**Subject:** FW: Tybalds Estate Regeneration Planning application ref:

2021/3580/P. Ref Block D

## Re: Tybalds Estate Regeneration Planning application ref: 2021/3580/P. Ref Block D

Figure 1: Diagram Showing percentage loss of VSC to Falcon flats.

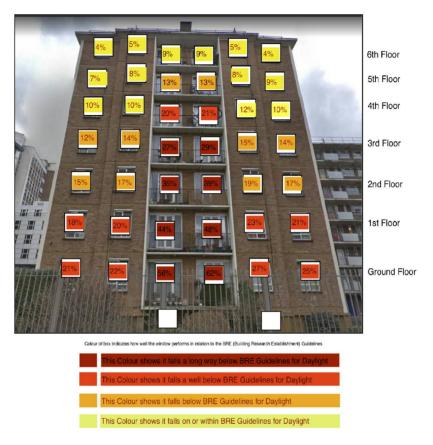
- Block D will have significant negative impact on the daylight and sunlight to Falcon and Richbell Residents (up to 62% reduction in VSC to habitable Falcon windows), both within their homes and to the shared courtyard amenity spaces. See figure 1 & 2 below. These blocks already suffer from poor living conditions.\*

- 9. The Daylight report is misleading, figures in the report are presented as 'percentage point' reductions not actual percentage reductions, and the colour coding (using **green** to highlight windows that **fail**) presents the findings disingenuously.

Diagram showing the pecentage (VSC) loss of daylight to each Falcon window as a result of new building opposite (on Richbell car park)

Fig 3. Falcon Extension configuration and flat layouts. Showing how 6 of 8 habitable room windows face East.

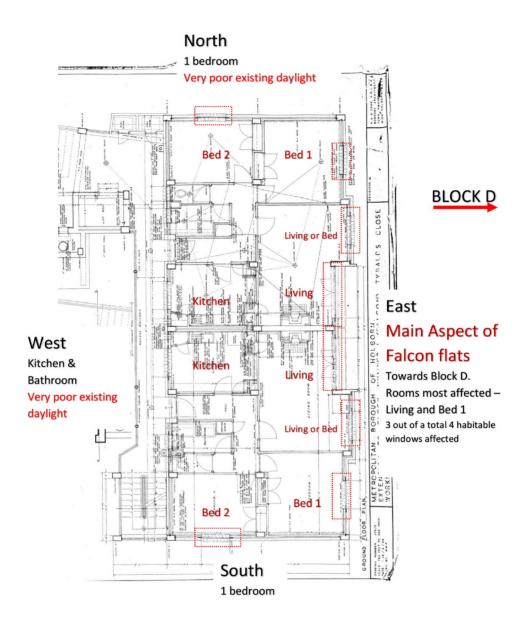
The external configuration of Falcon and internal flat layouts should be taken into consideration when assessing the impact of the new development.

The falcon extension is ostensibly East facing (see Fig 3), with each 2 bed flat having **2 of 3** habitable rooms (living room and 1 bedroom) facing east and in some cases 2 bedrooms facing east depending on adaptations within the flats. 3 out of 4 habitable room windows face Block D

The northern flats (Nos. 29, 31, 33, 35, 37, 39 & 41) have 1 north facing bedroom. So are severely limited to sunlight and daylight.

While all the flats are affected considerably. Those flats to the north are affected more, relatively, because they do not have a southern facing bedroom and Block D's position impacts their east facing windows more.
